STATE OF RHODE ISLAND
COASTAL RESOURCES MANAGEMENT COUNCIL
STAFF REPORT TO THE COUNCIL

Applicant's Name:	City of Pawtucket
CRMC File Number:	2026-01-0562026-01-056
Project:	<p>The Project is the second phase of the overall project associated with the Tidewater Stadium Development (Phase 1A). Phase 1B of the Project is a public/private joint development that proposes the following:</p> <ul style="list-style-type: none">• Construction of two pathways, a Lower Riverwalk (primary ADA public access path) and an Upper Riverwalk (secondary non-ADA maintenance access path). The upper path will consist of a stone dust stabilized aggregate and the lower path will consist of a combination of wooden boardwalk and asphalt paving to increase public visual access to the Seekonk River;• Construction of one (1) stormwater basin and associated stormwater control measures;• Construction of one (1) underground infiltration chamber (UIC) system and associated stormwater control measures;• Construction of an outdoor amphitheater area• Construction of the Tidewater East Plaza;• Restoration of wetlands and uplands at the Site, including establishment of an Urban Coastal Greenway (UCG) buffer zone• Establ

Figure 2: Overall layout of proposed Lots 1-4

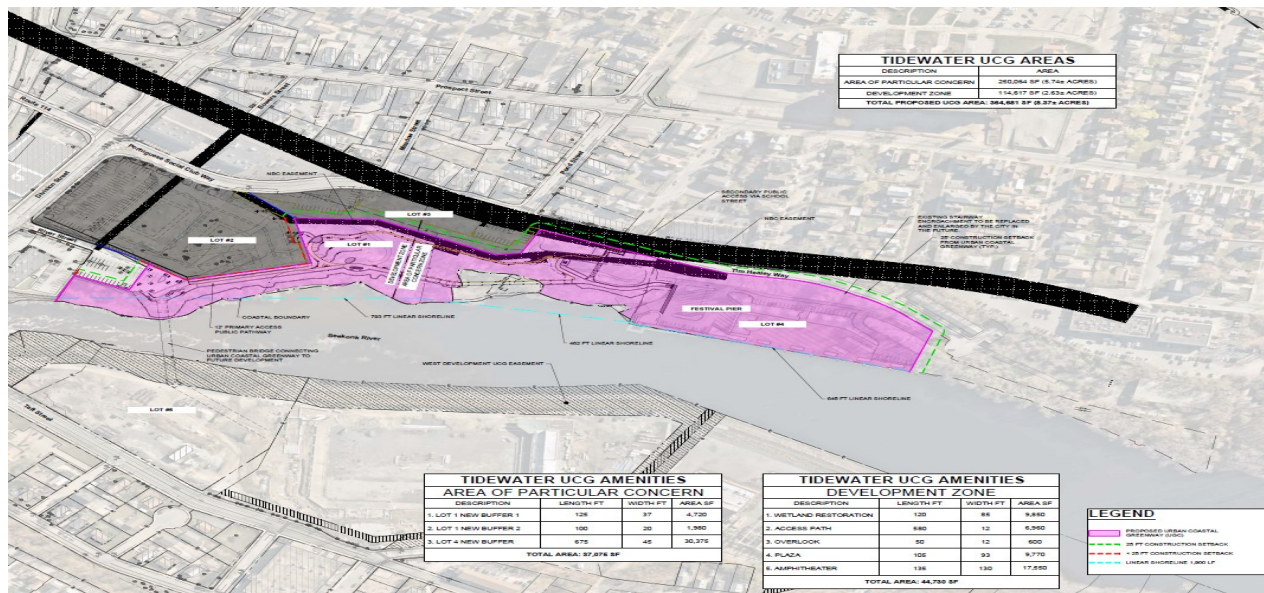
2—There are currently several parcels controlled by the City of Pawtucket in this area; Lots 599, 672, & 673 of AP 23 are proposed to be administratively reconfigured by the City should this project be permitted. The resulting parcels (Figure 2) will be Lot 1 (proposed UCG), Lot 2 (proposed Wood Development), Lot 3 (proposed Pennrose Development) and Lot 4 (part of AP 35A, Lot 361 containing Festival Pier). The entire parcel is located within either the MBS Development Zone or Area of Particular Concern Zone (**Figure 2**) and is bound by the river and adjacent streets. A Narragansett Bay Commission sewer easement and existing stormwater outfalls are also located across the parcels.
